Corcoran Planning Commission Agenda May 7, 2020 - 7:00 pm

a. **Public Hearing.** Open Space & Preservation Plat for "Paulsen Farms" (PID 09-119-23-34-0001) (city file no. 20-011)

Paulsen Farms Preliminary Plat Plan Review Memorandum

Subject: Plan Review -- Paulsen Farms Preliminary Plat Plan Review

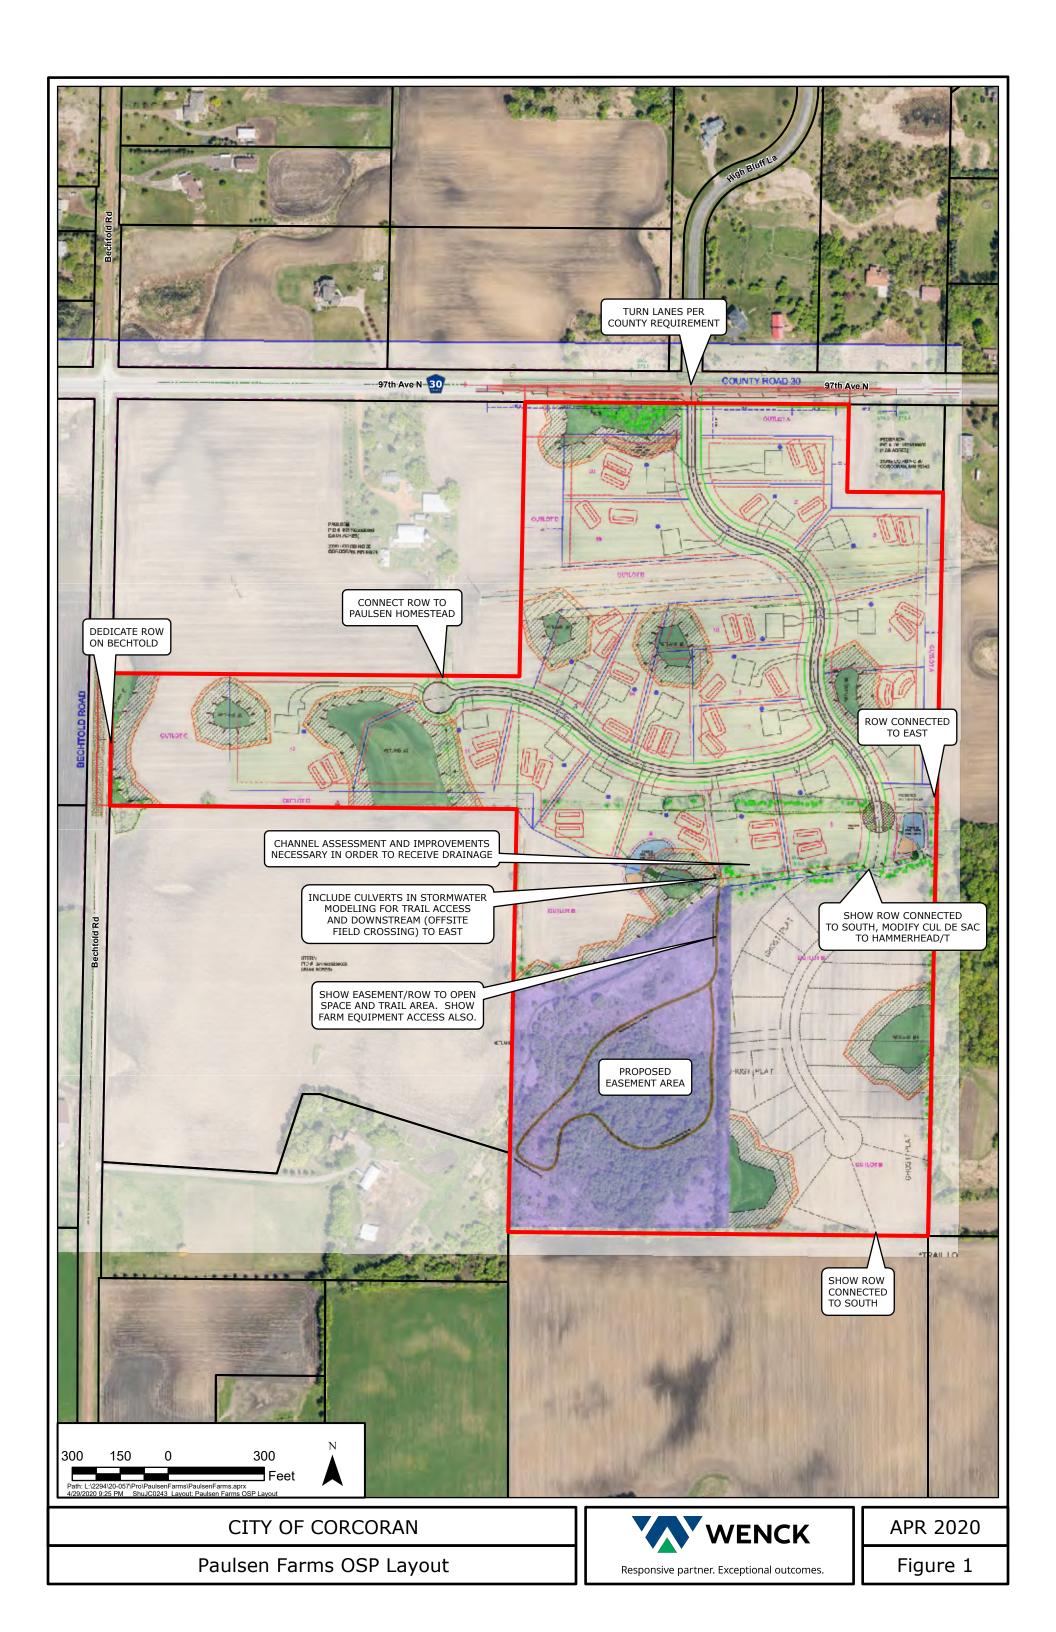
City street stubs are shown on Figure 1 and typical of City policy is to require adjacent parcels be provided public access. Dedicated ROW is required to the east, south to the open space, northwest to Paulsen farmstead. Final layout of temporary cul de sacs, connection points, etc. will be formalized during construction plan approval.

- Turn lanes at the main entrance can presumably be required by County via a project managed, designed, and constructed through City bid process will be implemented with developer escrow.
- Street stub ROW shall be dedicated to east, south and Paulsen farmstead are required.
- Public access to Open Space for trail and farm equipment is required.
- Further review of street layouts, turnarounds, etc. will occur during plan review process.

Lot Layouts

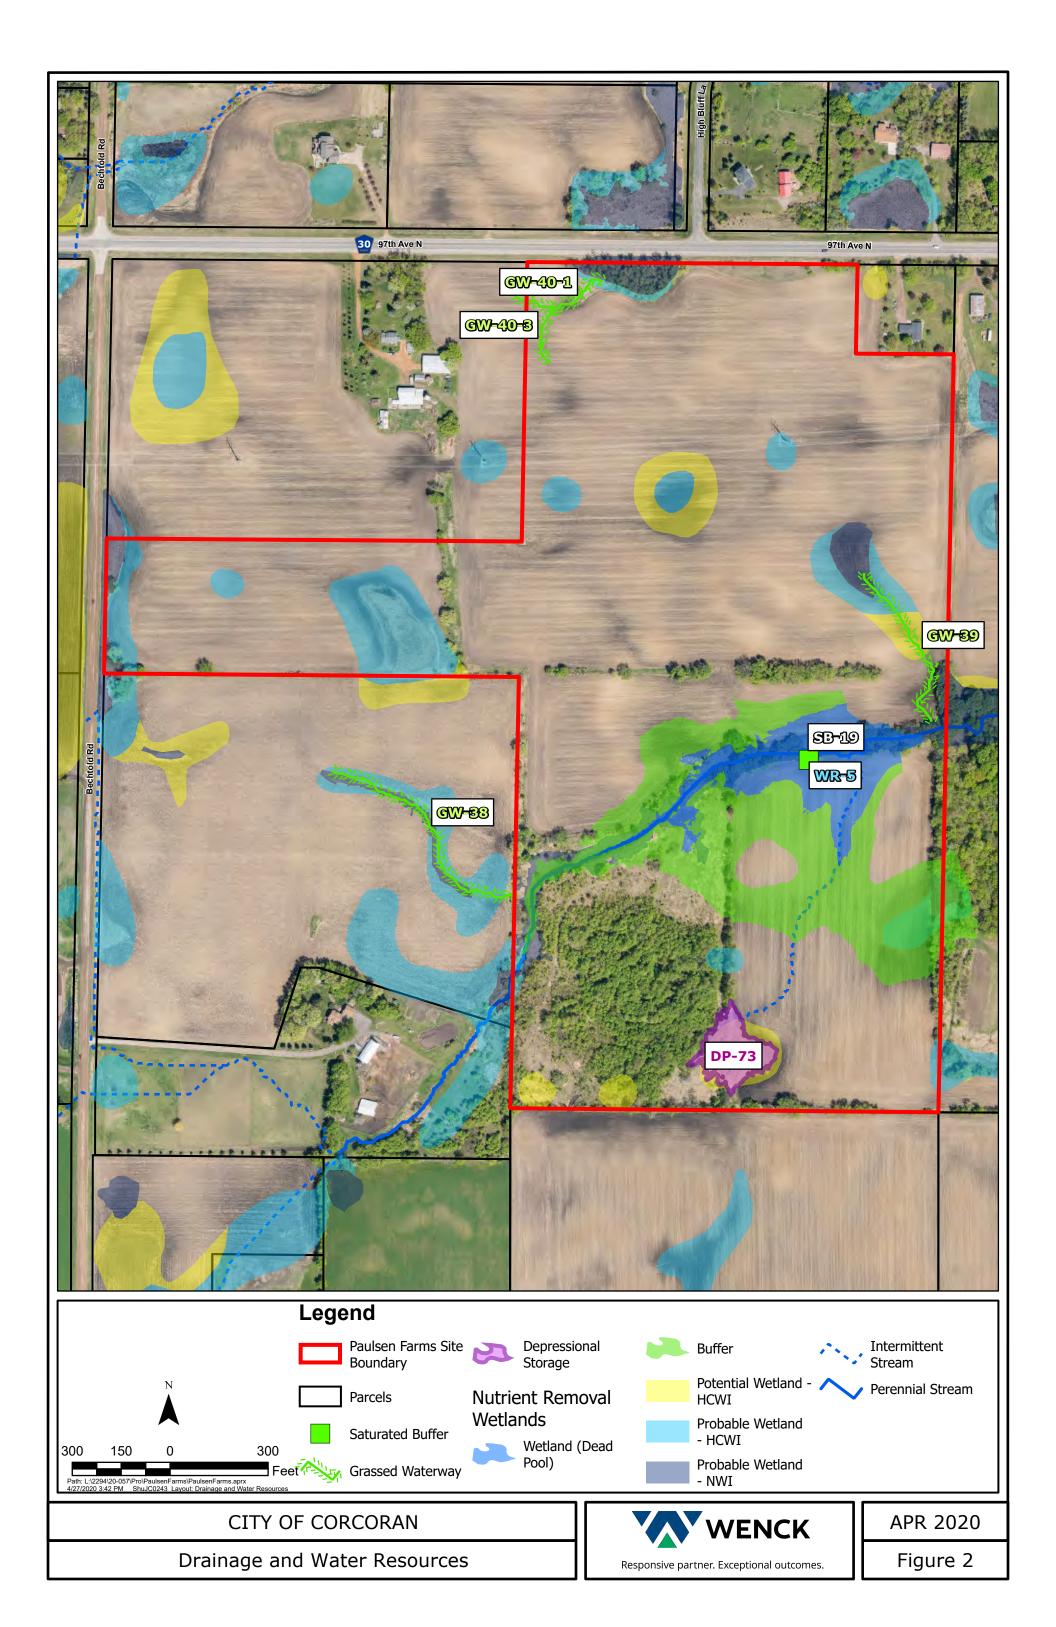
• Individual lot grading plans will be provided prior to final plat approval. These will be consistent with overall plans, but provide document to be followed for the building permit process.
